FREDERICK COUNTY PLANNING COMMISSION August 8, 2018

TITLE: Dunkin' Donuts - Jefferson

FILE NUMBER: SP-80-13, AP# 18324, AFPO# 18325, FRO#

REQUEST: Site Development Plan Approval

EXHIBIT 1 – Revised Site Plan

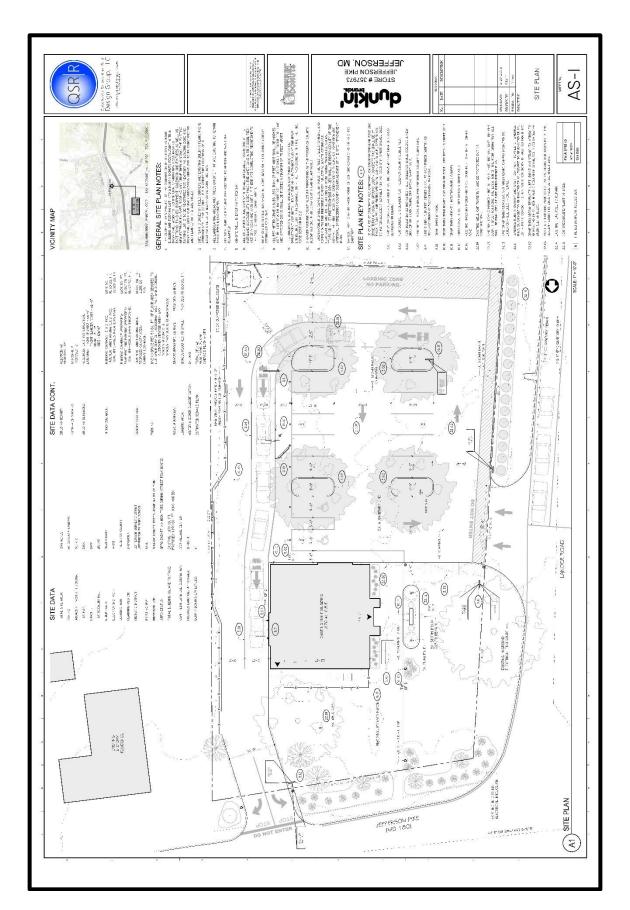
The revised proposed plan modifies the full movement existing access with Lander Road (SHA owned roadway) to permit a 'one-way in only' movement to the site, while maintaining the existing one-way exit drive onto Jefferson Pike. To aid in the safe ingress of traffic from Lander Road, the applicant will be making some changes to the existing signal timing at MD 180/Lander Road and stop bar placement on the northbound Lander Road approach, and will add regulatory directional signing, as directed by SHA as part of a SHA Access Permit package. The road striping previously illustrated at the Lander Road entrance has been removed from the SHA right-of-way at the request of SHA.

vehicular queuing to allow the stacking of more than 10 vehicles without blocking access to the parking aisles for those visitors not making use of the drive-through lane. A 'bail out' lane is also provided along the southern and eastern edges of the site and serves to provide access to the dumpster enclosure. The required loading space (10'x50') has been moved to an area adjacent to the south property boundary.

- 1) Shifting the location of the required loading space to the southern edge of the site;
- 2) Removal of the road striping within the SHA r.o.w. at the proposed entrance;
- 3) Removal of two (2) parking spaces on the southern end of the parking area in order to provide an area for the relocated loading space while allowing for a wider travel lane adjacent to the drive-through queue. This revision would eliminate the narrow 'pinch point' between the northwestern corner of the dumpster enclosure and vehicles in the drive-through lane.
- 4) Providing stop signs to control internal circulation (on or near the northwestern parking island) in order to better manage this convergence point where incoming traffic may conflict with vehicles circulating within the site after leaving the parking area.

- 7. The Applicant shall: a) eliminate two (2) of the fourteen (14) parking spaces to facilitate the relocation of the loading space to an area parallel to the southern property boundary, and b) provide stop signs to control internal circulation (on or near the northwestern parking island) in order to better manage this vehicular convergence point.
